Addendum 66 – UN Regulation No. 67

Revision 4 - Amendment 1

Supplement 15 to the 01 series of amendments – Date of entry into force: 16 October 2018

Uniform provisions concerning the approval of:

Arrangement of the LPG equipment type approval mark

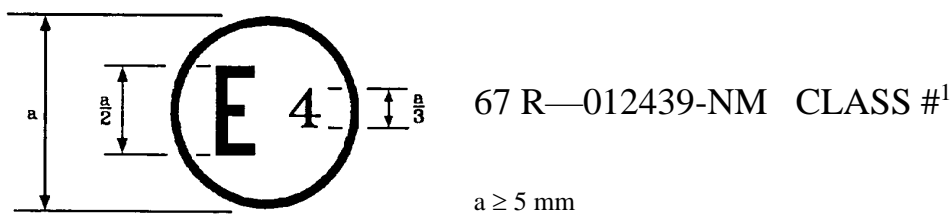
Annex 2A, amend to read:

$a \geq 5$ mm

¹ Class 0, 1, 2, 2A or 3.

² Indication mark of technical modification to be marked only on multivalve or, when approved separately, on pressure relief valve (discharge valve) and pressure relief device.

The above approval mark affixed to the LPG equipment shows that this equipment has been approved in the Netherlands (E 4), pursuant to UN Regulation No. 67 under approval number 012439. The first two digits of the approval number indicate that the approval was granted in accordance with the requirements of UN Regulation No. 67 as amended by the 01 series of amendments. The indication mark of technical modification (A in the example), preceded by the star symbol, is required only for the approval mark of the accessories of the container (multivalve or, when approved separately, pressure relief valve (discharge valve) and pressure relief device)."
